Addendum: **3**
 Date: **3/14/2025**
 Project: **FWCS HPB Natatorium HVAC Improvements**

Comm #: **24634**

FORT WAYNE COMMUNITY SCHOOLS
HELEN P. BROWN NATATORIUM
HVAC IMPROVEMENTS
3301 S Calhoun St, Fort Wayne, IN 46807

SHEET:
E201

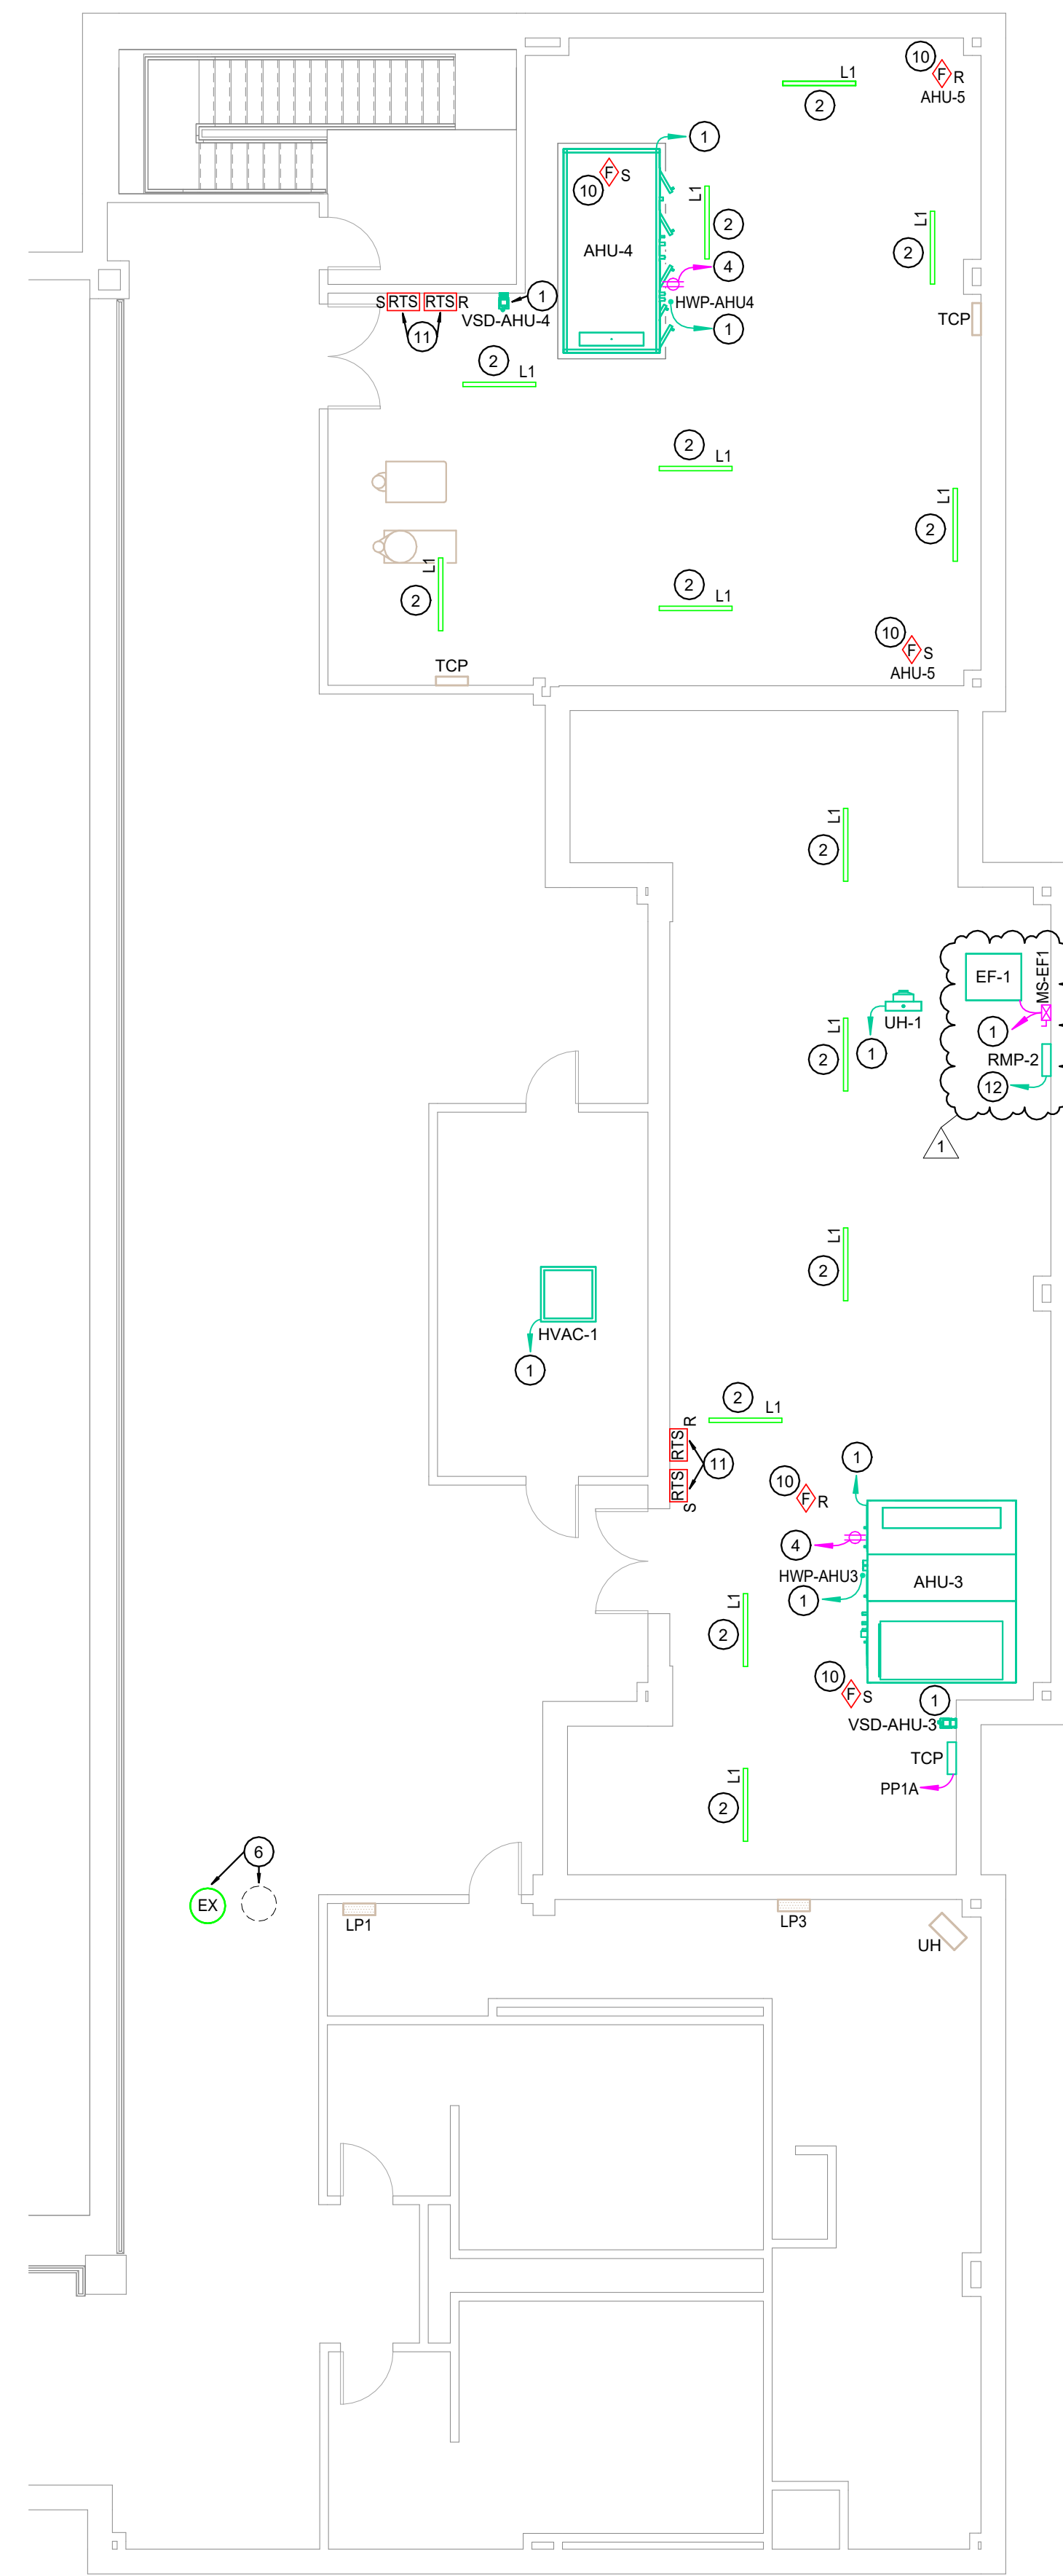
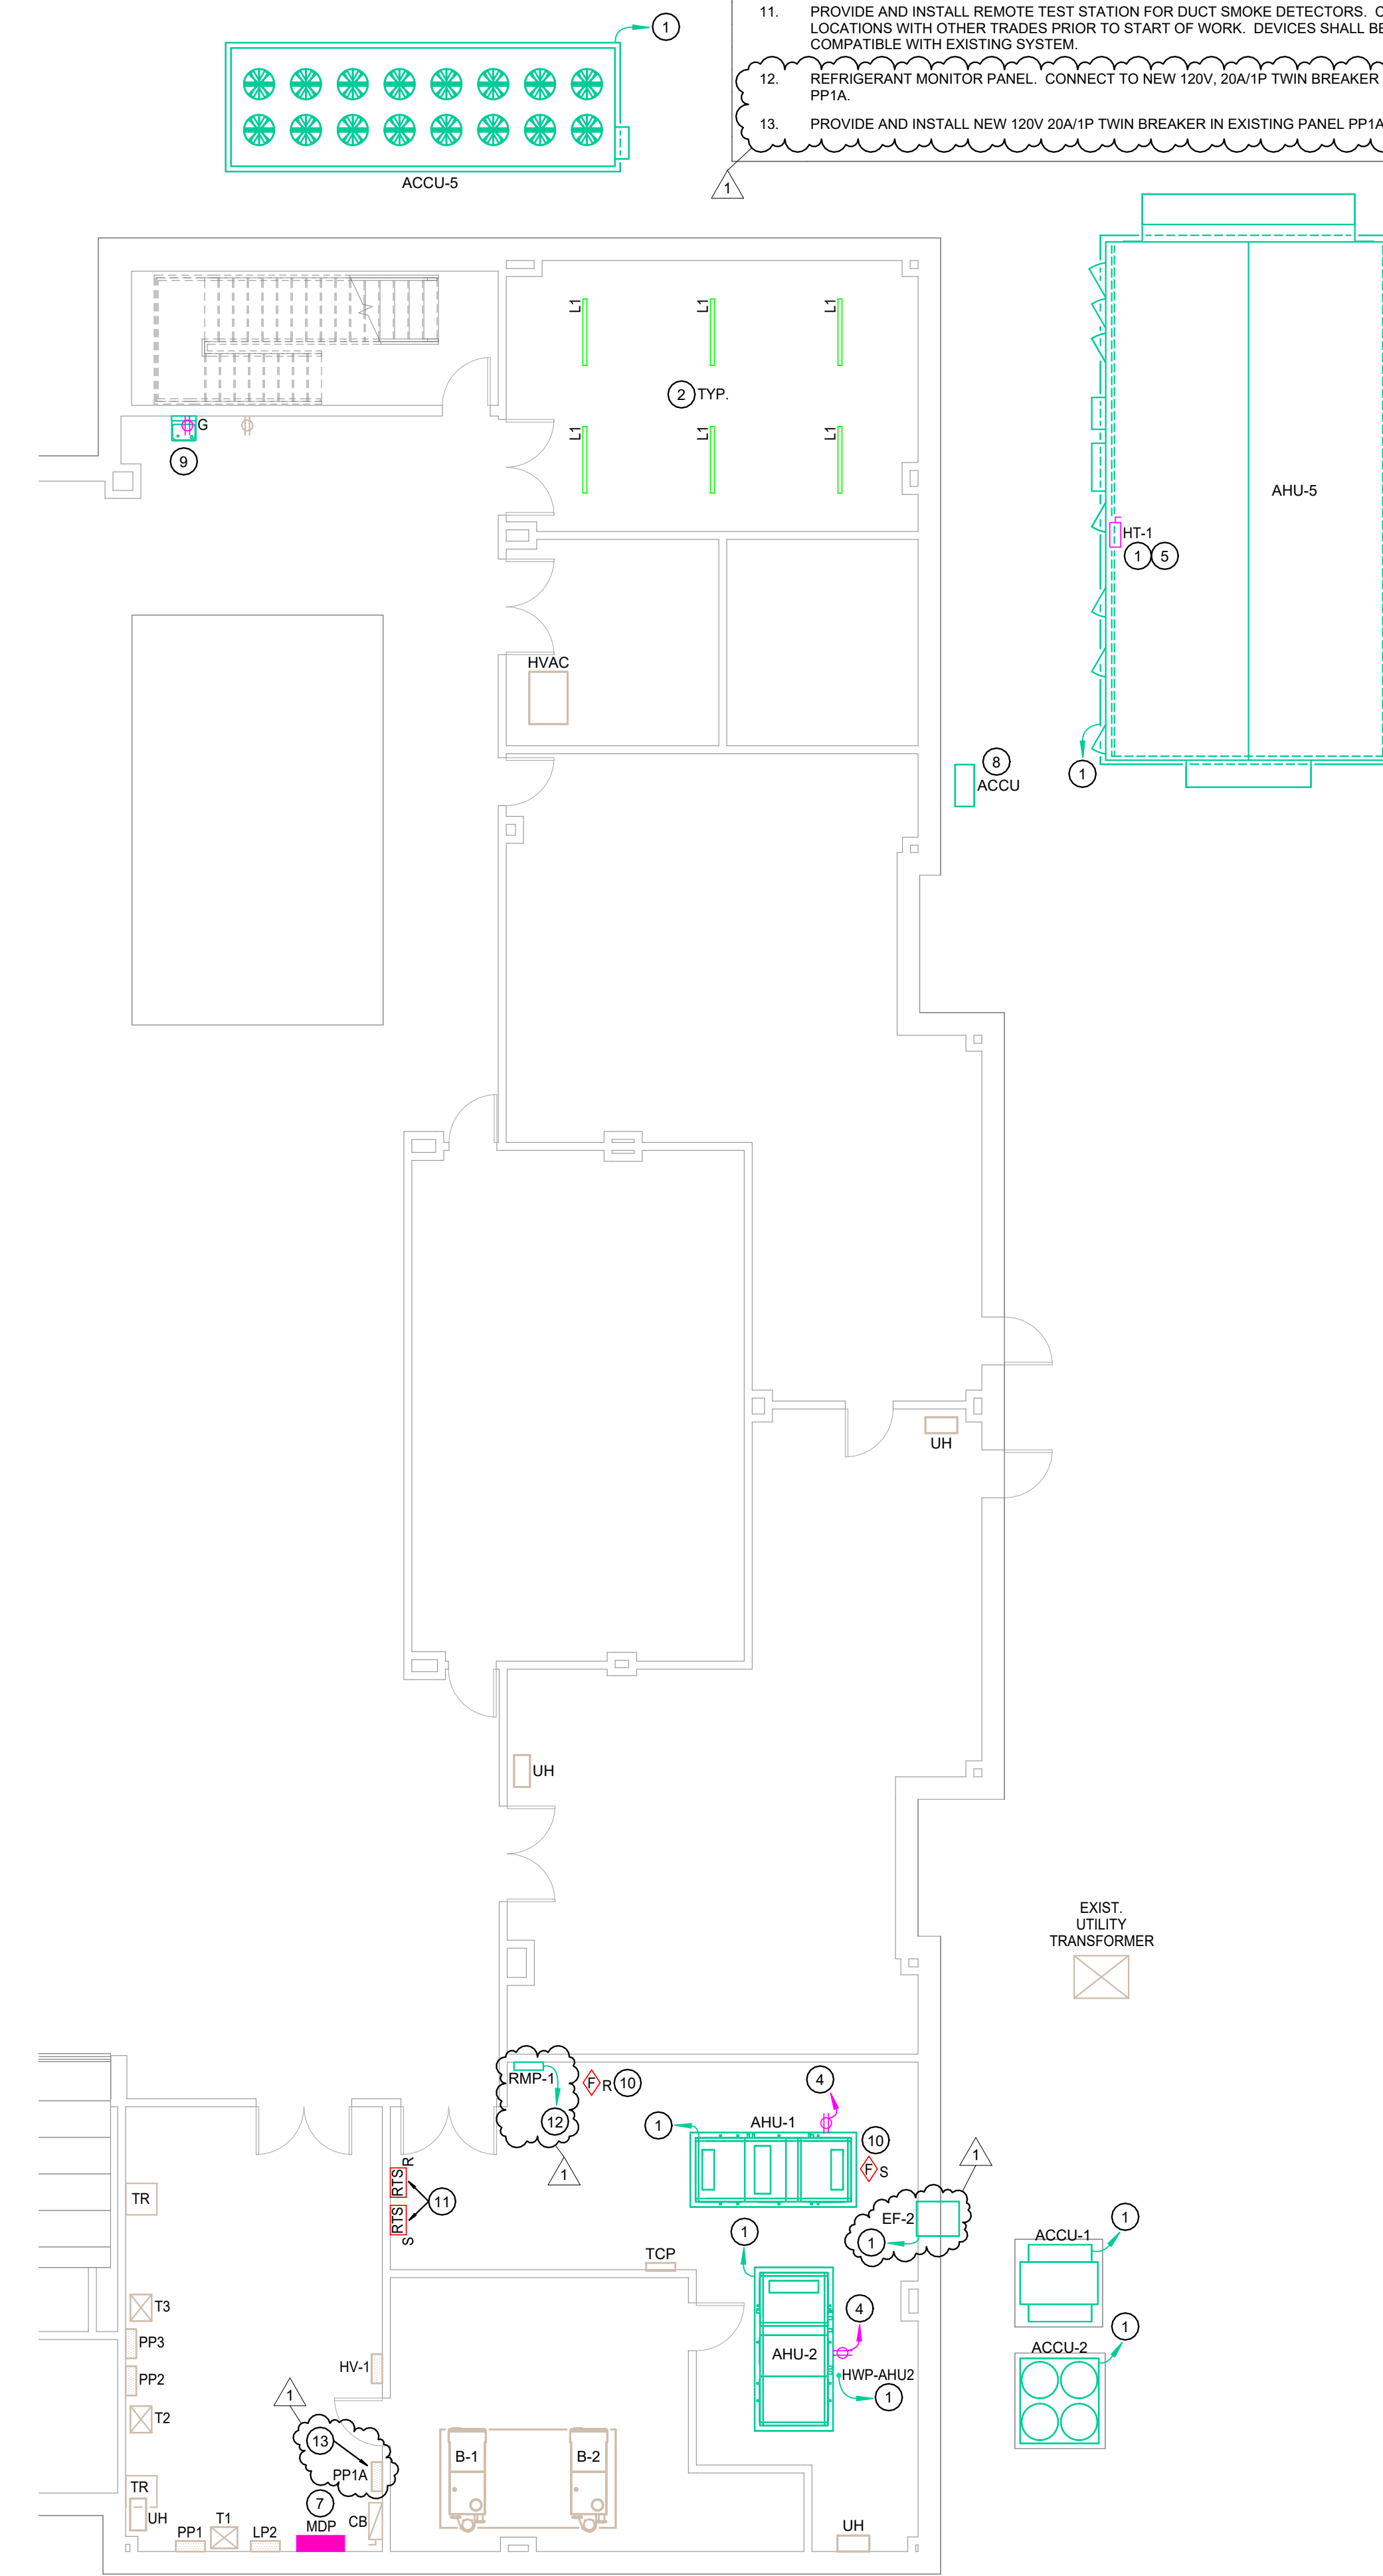
- A. Add power to EF-1 & EF-2 and (2) RMP (refrigerant monitor panel). See attached drawing revision to E201 dated 3/14/2025.

- B. Clarification" any conduit in Natatorium shall be PVC-80, cleaned, prepped, primed and painted two coats.

- REFRIGERANT MONITOR PANEL. CONNECT TO NEW 120V, 20A/1P TWIN BREAKER IN EXISTING PANEL PPIA.
 - PROVIDE AND INSTALL NEW 120V 20A/1P TWIN BREAKER IN EXISTING PANEL PPIA.

SHEET:
E401

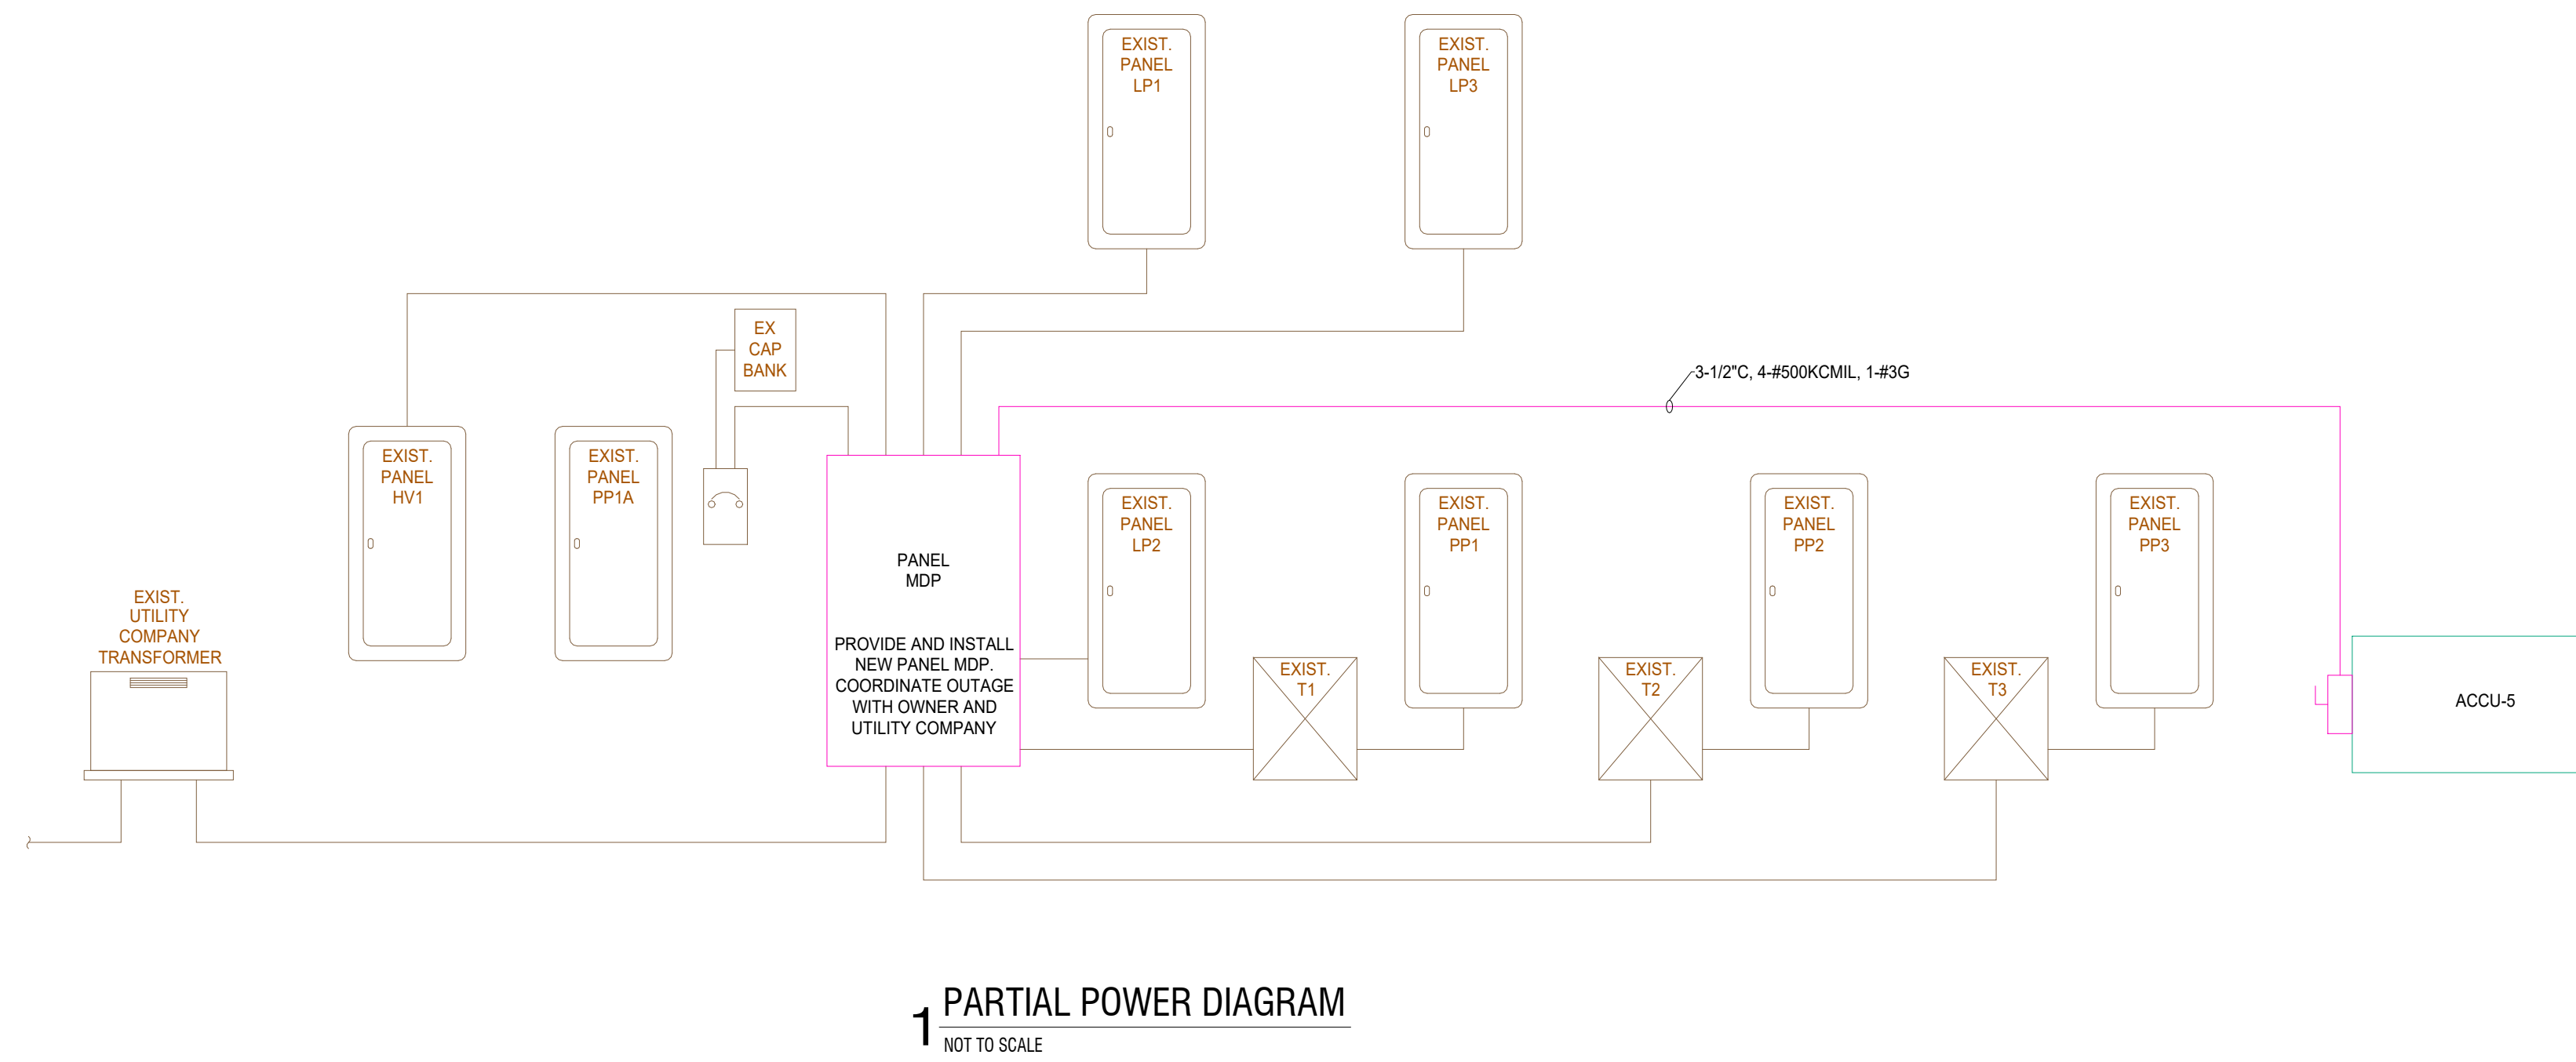
- A. Add EF-1 & 2 to Equipment Schedule. Add breaker in Panel HV1 for EF-1. See attached drawing revision to E401 dated 3/14/2025.

EF-1	2ND FL MECH RM	3 HP	480V/3PH	3/4"C, 4-#10, 1-#10 GROUND	HV-1	EC	NF	1	30/3	X				EC	9	MC	FWR	30/3	1	3	
EF-2	1ST FL BOILER RM	3/4 HP	120V/1PH	3/4"C, 2-#12, 1-#12 GROUND	PP1A	EC	NF	1	30/1	X										4	
UH-1	2ND FL STORAGE	1/3 HP	120V/1PH	3/4"C, 2-#12, 1-#12 GROUND	PP2-27	EC	NF	1	20/1	X											
HT-1	AHU-5	1200W	277V/1PH	3/4"C, 2-#10, 1-#10 GROUND	LP3-13	EC	NF	3R	20/1	X											2
SCHEDULE ABBREVIATIONS																					
A	AMPACITY	HLO	HIGH/LOW/OFF SWITCH	MHLO	MOMENTARY HIGH/LOW/OFF SWITCH																
EC	ELECTRICAL CONTRACTOR	HOA	HAND/OFF/AUTO	NF	NON-FUSED																
EX	EXISTING EQUIPMENT	HP	HORSE POWER	O	OWNER FURNISHED AND INSTALLED																
F	FUSES	INT	INTEGRAL WITH EQUIPMENT	RLA	RUNNING LOAD AMPS																
FLA	FULL LOAD AMPS	LOR	LOCAL/OFF REMOTE SWITCH	S	ON/OFF SWITCH																
FWR	FULL VOLTAGE NON-REVERSING	M	MOMENTARY ON/OFF SWITCH	W	WATTS																
G	GENERAL CONTRACTOR	MC	MECHANICAL CONTRACTOR	XAYP	X AMP CIRCUIT BREAKER, Y POLE

4. PROVIDE AND INSTALL NEW 120V, 25A/1P BREAKER IN EXISTING PANEL PP1A. RELOCATE BREAKERS TO ALLOW NEW INSTALLATION.
